CITY OF KNOXVILLE CLOSURE OF PUBLIC RIGHT-OF-WAY

▶ **FILE #:** 10-A-22-SC **AGENDA ITEM #:** 5

▶ **RIGHT-OF-WAY TO BE CLOSED:** S. Twenty First St.

RE: REQUEST CLOSURE OF A SECTION OF S. TWENTY FIRST ST. BETWEEN CLINCH AVE. AND WHITE AVE. (10-A-22-SC)

File No. 10-A-22-SC (Gas)

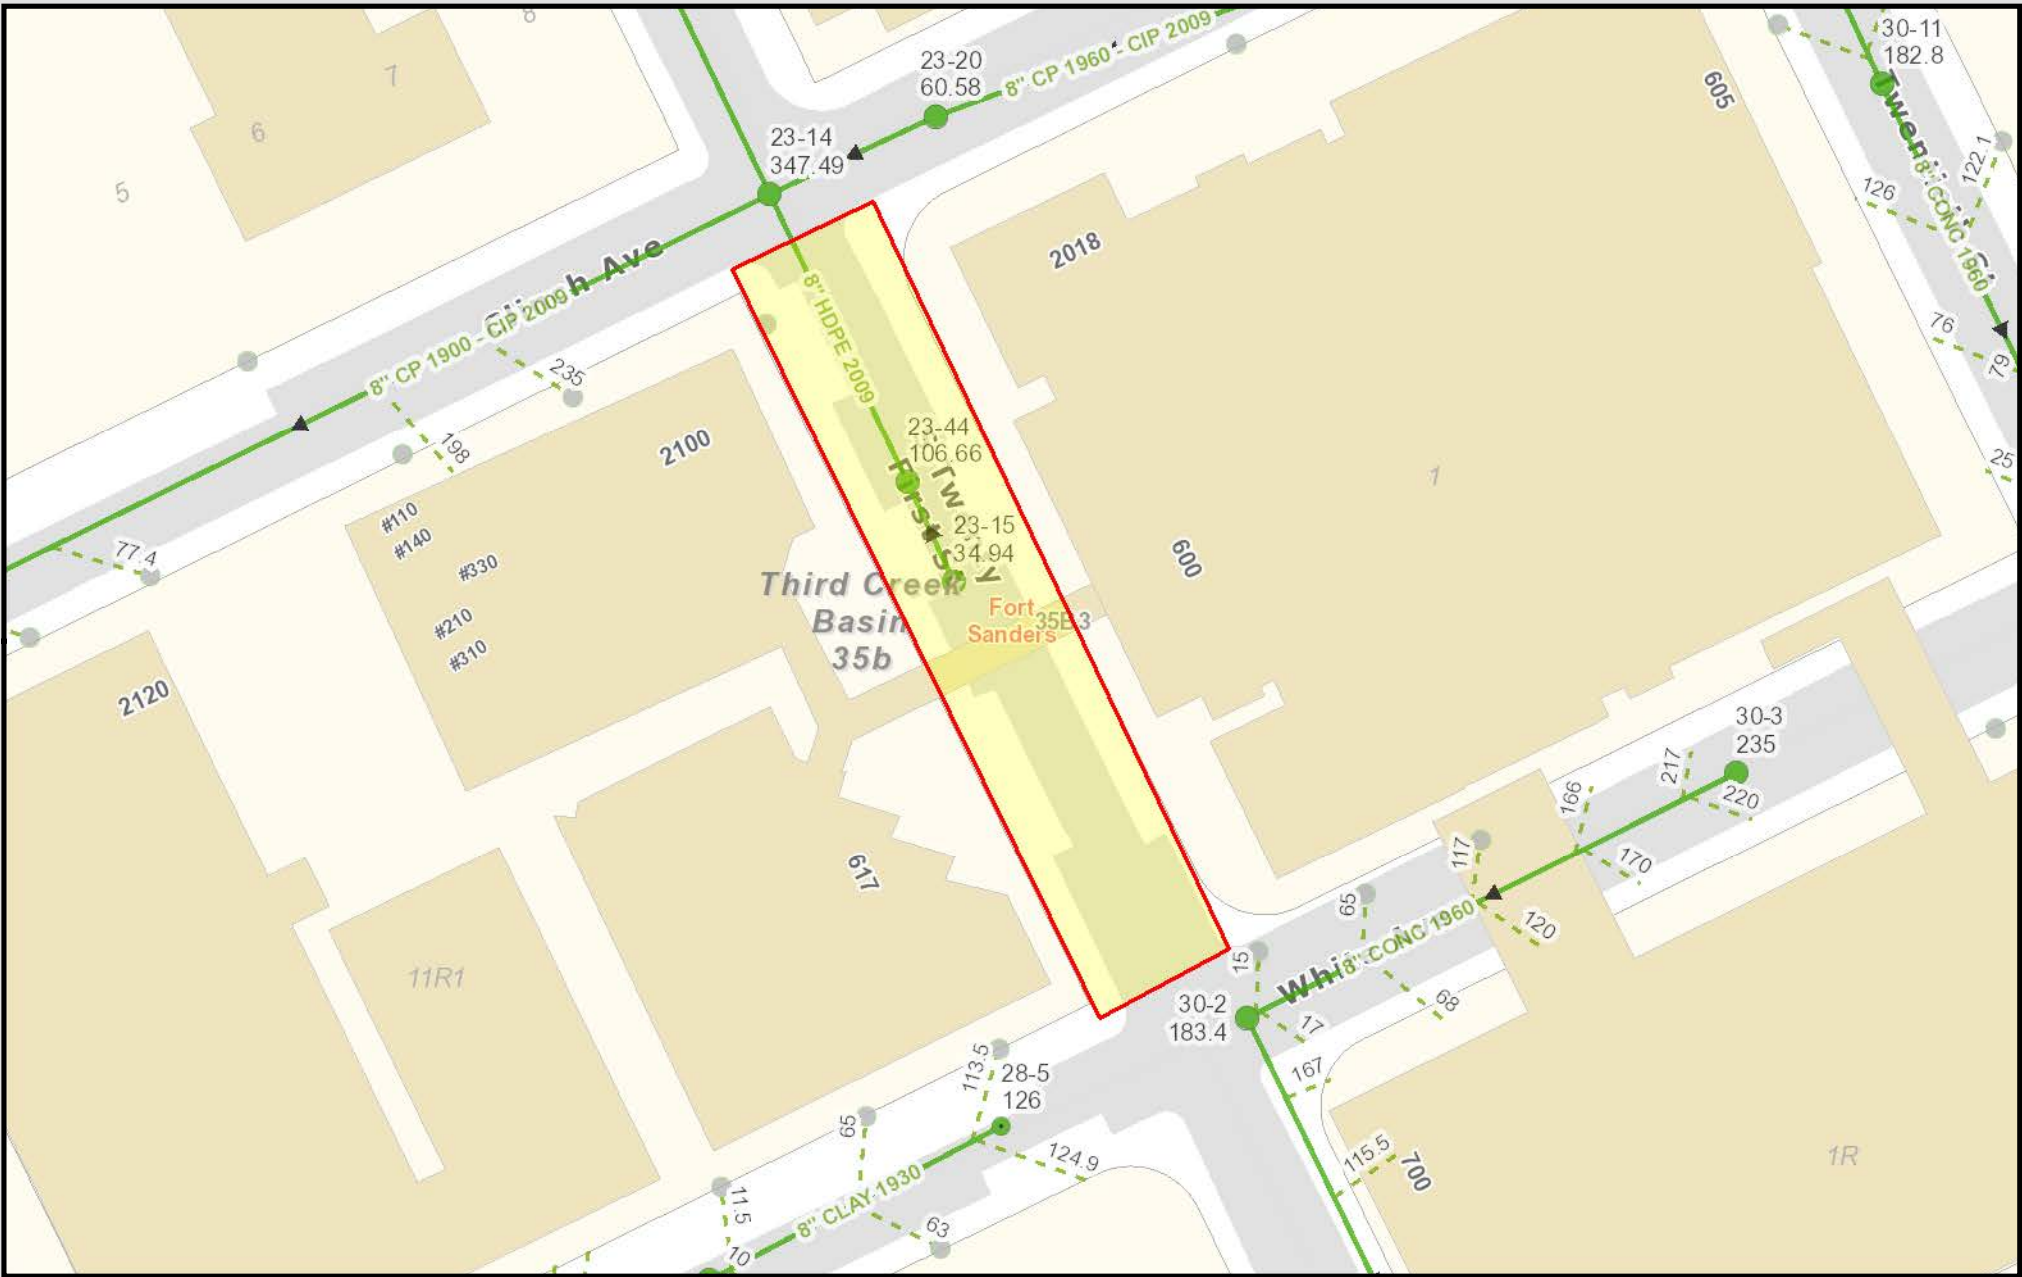
We have reviewed our records and find that we have existing utility facilities located within the subject right-of-way. The approximate locations of these facilities are indicated on the enclosed prints. However, KUB does not release and hereby retains all easements and rights for existing utility facilities, whether or not shown on these prints.

Should this right-of-way be closed, KUB will require the following permanent easements for its utility facilities.

Gas – 7.5 feet on each side of the centerline of the gas line, 15 feet total width
Sewer – 7.5 feet on each side of the centerline of the sewer line, 15 feet total width
Water – 7.5 feet on each side of the centerline of the water line, 15 feet total width
